PROPOSED PLAN CHANGE 119

(Private): Ara Hills (Hall Farm)

SUMMARY OF DECISIONS REQUESTED

Figure 1: Location of stormwater culvert systems (in purple)

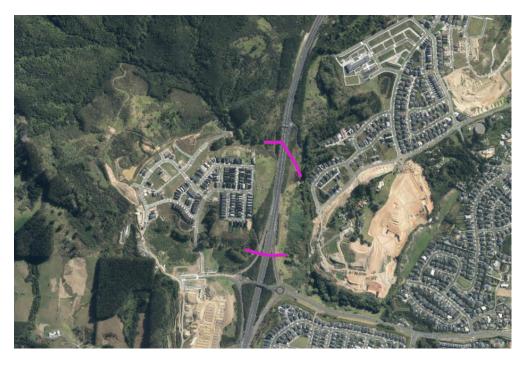
5.2 NZTA's stormwater engineers raised concerns about the effects the proposed plan change will have on the flood resilience of the highway system. NZTA has two stormwater culvert systems (see Figure 1) that will be impacted by the proposed plan change. These culvert systems were initially built in the 1990s and 2000s as part of the ALPURT B1 and B2 projects. The culverts have limited performance capability, were designed for maximum probable discharge scenarios applicable under the Auckland Council Regional Plan: Air, Land and Water at the time, and are currently in a moderate condition. NZTA has concerns about the additional demand and risk that increased flows will present to the resilience of the highway during major stormwater events.

5.3 The applicant's Engineering Report suggests that no flood control is required due to limitations within NZTA's system. However, it is essential that the proposed development does not adversely impact on these

culvert systems or the resilience of the highway system embankment. The proposed plan change will result in a measurable increase to rates and volumes of runoff, and thereby presents a flood resilience risk to the state highway network as increased flood depths and velocities against the motorway embankment present a measurably greater risk of erosion, scour and risk for failure of the embankment and culvert systems.

Figure 1: Amended Precinct Plan 1, to indicatively show the changes required as a result of this part of the submission

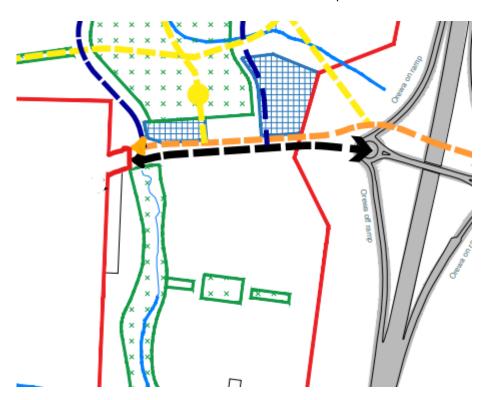
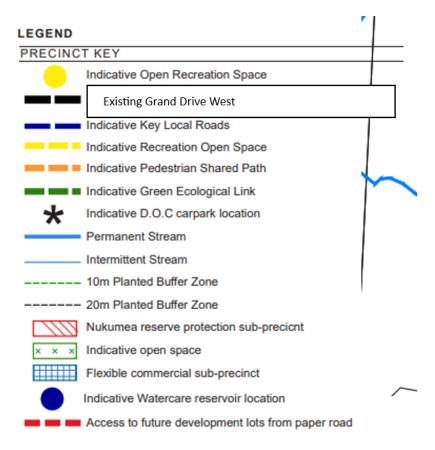
- 6.1 Precinct Plans 1 and 2 currently show an "Indicative Future Arterial Rd with restricted vehicle access". This road is largely completed, except for a small section on the western end that connects to the Precinct boundary and is required to vest as a paper road.
- 6.2 The Submitter seeks that Precinct Plans 1 and 2 are amended as follows:

- (a) The Legend is changed from "Indicative Future Arterial Rd" to "Existing Grand Drive West".
- (b) Shorter black and orange dashed lines such that the Grand Drive West does not connect to the notified Precinct western boundary, reflecting the actual extent of constructed road and shared path.
- (c) The Precinct Plans are amended to remove the area of vested paper road subject to NoR 6 from the Precinct, bringing a small part of the boundary eastward.
- (d) See indicative amended Precinct Plan 1 and Legend below, other Precinct Plans would need to be amended to be consistent with this plan.

(4) Standard E27.6.4.1(3) applies to the site boundaries along <u>Grand Drive West</u> the Indicative Future Arterial shown on Precinct Plan 1. No vehicle crossings are allowed off <u>Grand Drive West</u> the Indicative Future Arterial

(B) To remove the unformed or 'paper road' part of Grand Drive West from the Precinct as shown on Figure 1; and
